How to coexist between AUTOSAR and IEEE – sequel -

***Japan
Automotive
Software
Platform
and
Architecture***

2023.3.14

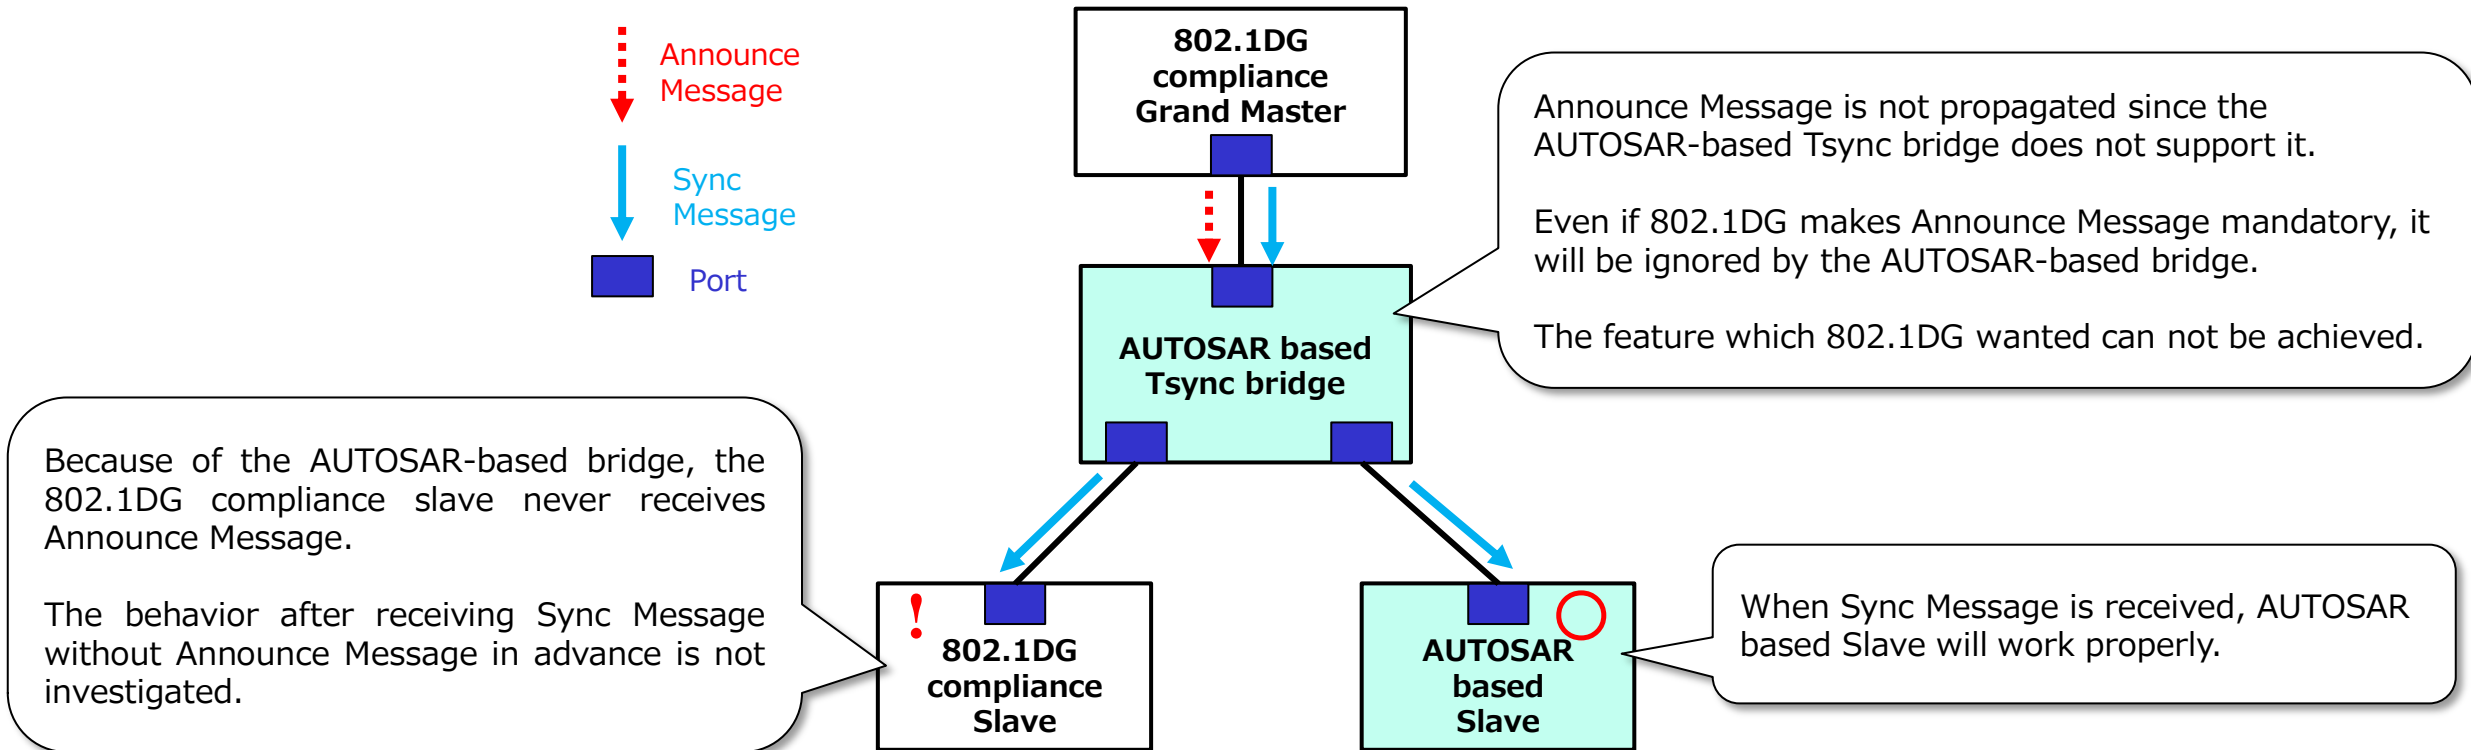
According to the current automotive use cases, Announce Message is not necessary.

However, considering the new use cases that require Announce Message will appear soon, we propose Announce Message as an Option in the Extended Profile.

The problems cannot be overlooked for OEMs

While AUTOSAR specification CANNOT use Announce Message, OEMs are urged to select one bridge specification among AUTOSAR or 802.1DG.
⇒ OEMs choose only AUTOSAR if the 802.1DG bridge is not off the shelf.

When profiles of AUTOSAR and 802.1DG are mixed in the same system, the below problem occurs for example.
⇒ OEMs have no choice but to unite into AUTOSAR. (This means 802.1DG will be prohibited.)
